Final Work Plan Addendum #1
for the Sampling of Soils Below Floor Slabs and Remediation at
RVAAP-08 Load Line 1 and Other Building Locations

Ravenna Army Ammunition Plant
8451 St. Route 5
Ravenna, OH 44266-9297

**DRAFT OF WORK PLAN ADDENDUM #1 FOR THE SAMPLING OF SOILS BELOW FLOOR SLABS AND
REMEDATION AT RVAAP-08 LOAD LINE 1 AND OTHER BUILDINGS
COMMENT RESPONSE TABLE
JULY 23, 2009**

URS				
RAVENNA ARMY AMMUNITION PLANT RAVENNA, OHIO				
SOIL SAMPLING UNDER FLOOR SLABS				
PROPOSED CORE LOCATIONS BUILDING CB -10				
DRAWN BY: JSC	CHECKED BY: SL	PROJECT No: 13812319	DATE: 7/30/09	FIGURE No: 3-4 PAGE No: 3-13

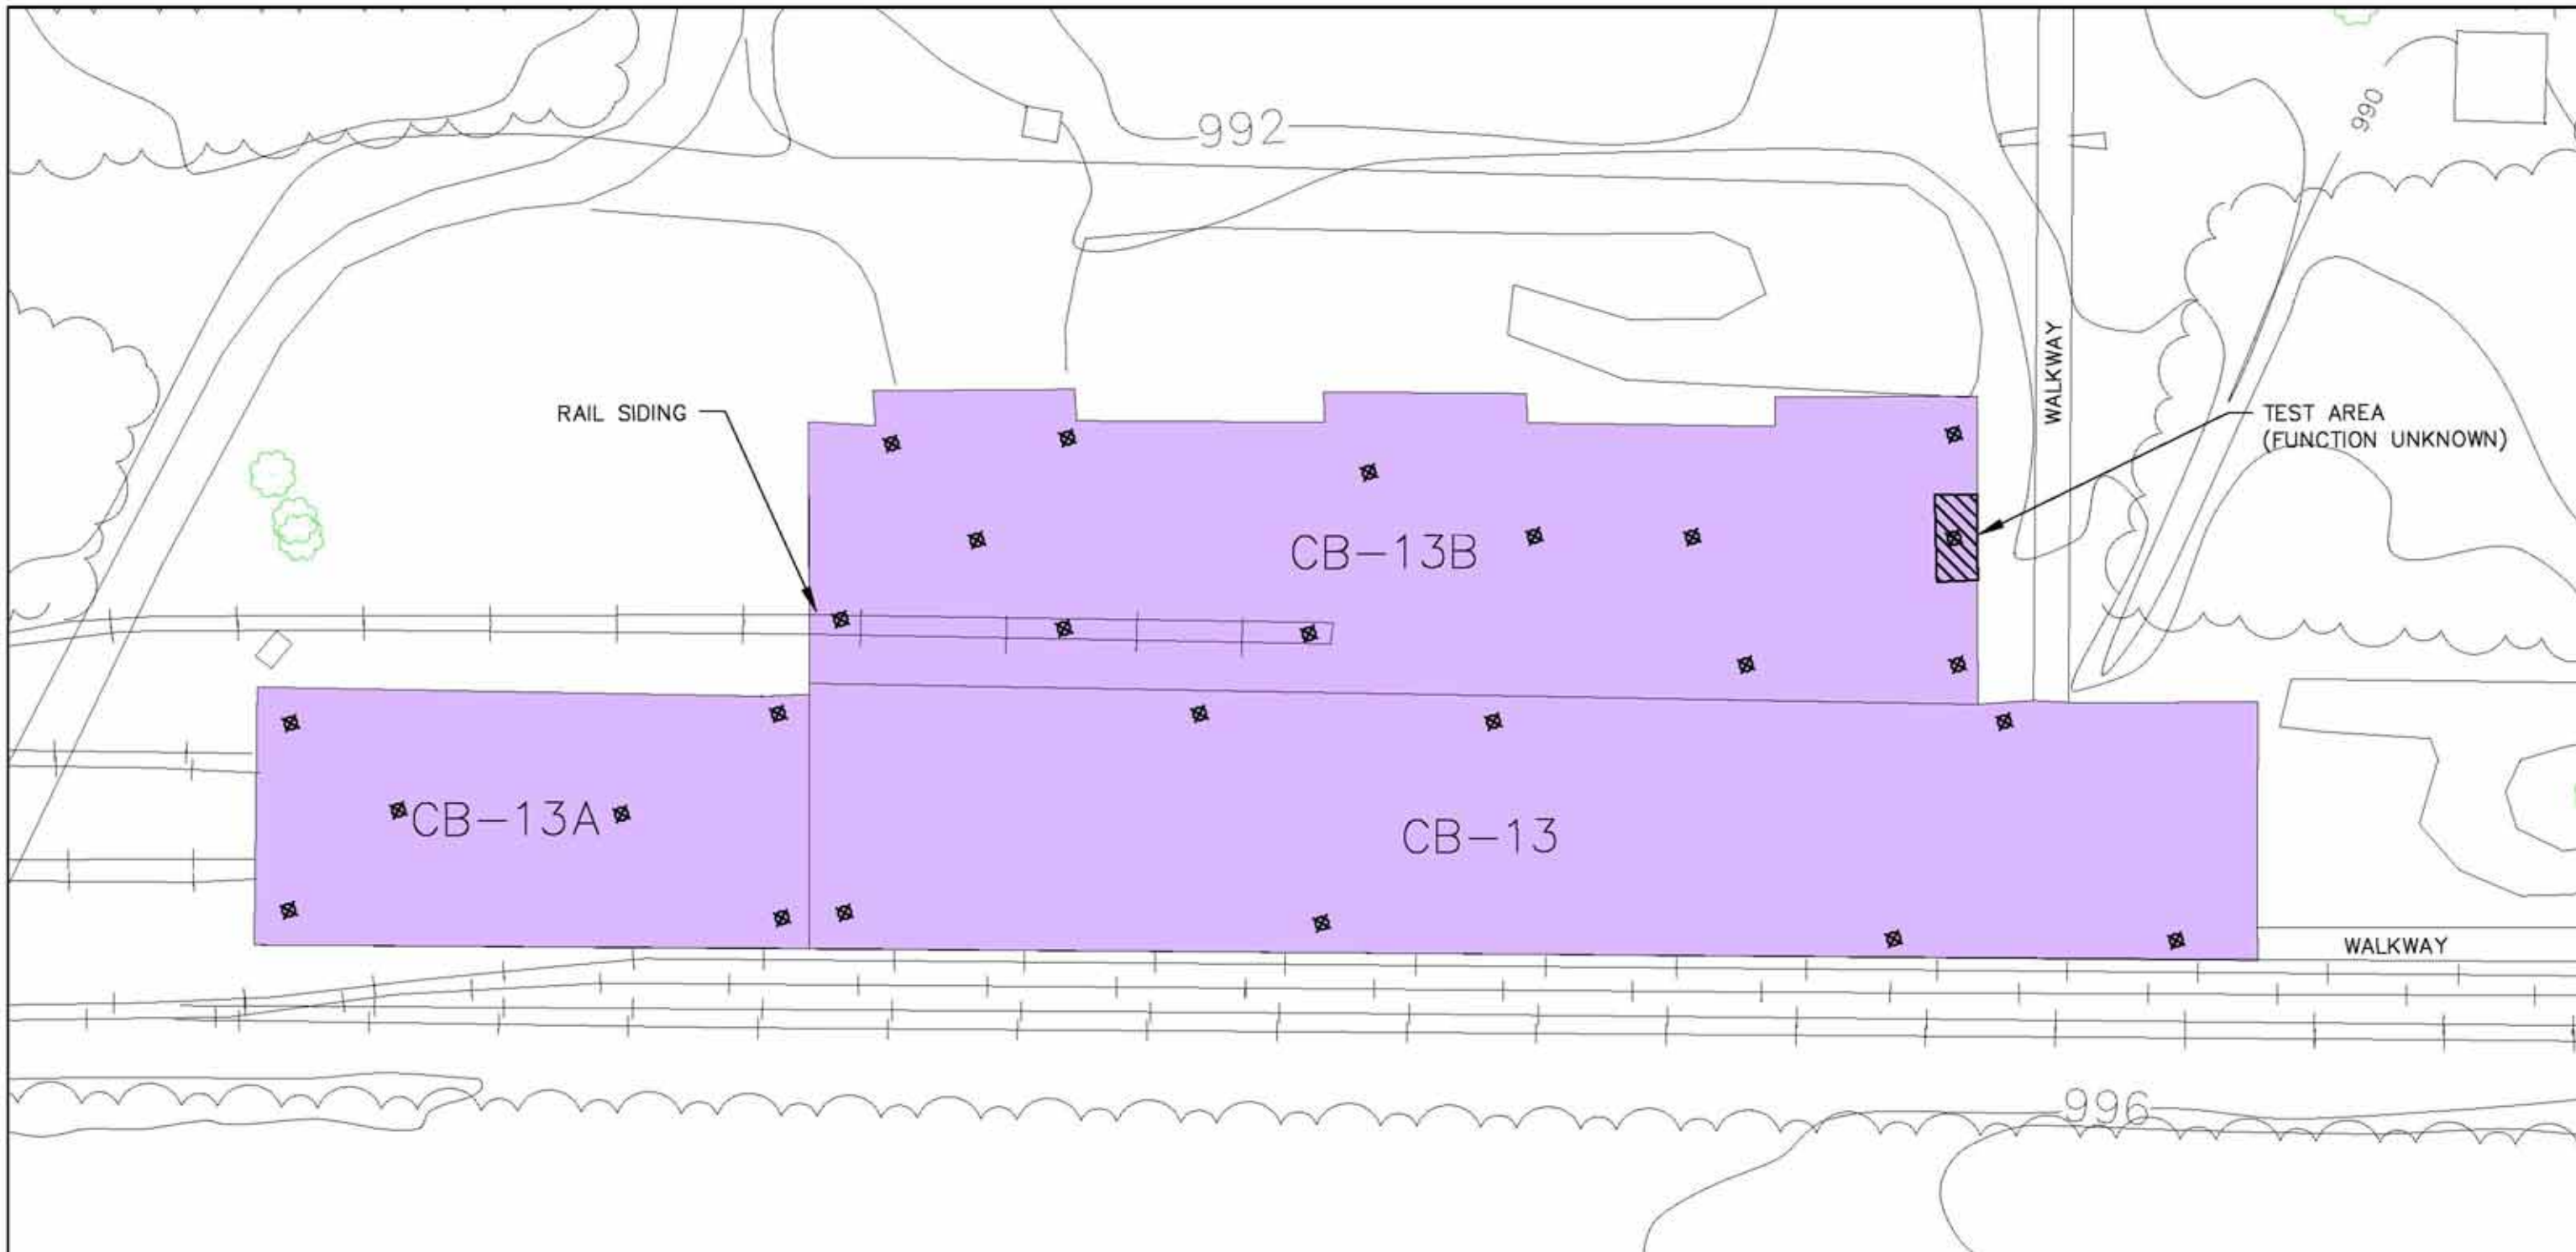
Comment Number	Page No./ Line No.	New Page or Sheet	Comment	Recommendation	Response
					<p>d. Noted. The key has been revised to match the figure.</p> <p>e. Noted. Walkways have been added to the figure key.</p>
23	Figure 3-4		Revise figure.	<p>a. Clarify the discharge points for the drains depicted on the figures.</p> <p>b. Add polygon shape to the key.</p> <p>c. Add square shape to the key.</p> <p>d. Add large circle to the key.</p> <p>e. The RR tracks in the figure do not match the key. Revise to be consistent.</p> <p>f. Add to the key what is meant by the circle with the dot inside and NE trending line segment.</p> <p>g. Add a few contour elevations to the figure.</p> <p>h. Add walkways to the key.</p>	<p>a. The discharge points for the listed drain could not be ascertained during the inspection due to the demolition and removal of the drain pipes.</p> <p>b. Noted. The polygon shape representing the vacuum unit enclosures has been added to the figure.</p> <p>c. Noted. The square shape representing small structures has been added to the key.</p> <p>d. The large circles are the labels indicating the number assigned to the vacuum pump house (See Figure 1-2). These labels have been removed from Figure 3-4 and the VP buildings labeled appropriately.</p> <p>e. Noted. The key has been revised to match the figure.</p> <p>f. The circle with a dot and line are identified as steam stanchions in Figure 1-2. The figure legend will be modified to clarify.</p> <p>g. Available contour elevation values have been added to the figure.</p> <p>h. Walkways have been added to</p>

Comment Number	Page No./ Line No.	New Page or Sheet	Comment	Recommendation	Response
					the figure legend.
24	Figure 3-5		Revise figure.	<ul style="list-style-type: none"> a. The RR tracks in the figure do not match the key. Revise to be consistent. b. Add rectangle to the key. c. Add square to the key. d. Describe what is meant by “test area.” e. Add a few contour elevations to the figure. f. Add walkways to the key. 	<ul style="list-style-type: none"> a. Noted. The key has been revised to match the figure. b. Noted. The rectangle shape representing small structures has been added to the key. c. Noted. The square shape representing small structures has been added to the key. d. Based upon the field inspection, the test area is an area where unknown testing was conducted. Remnants of containment and an exhaust hood remain. The figure has been modified to note former test area with unknown purpose. This information was also added to Section 3.6.3. e. Available contour elevation values have been added to the figure. f. Noted. Walkways have been added to the figure key.
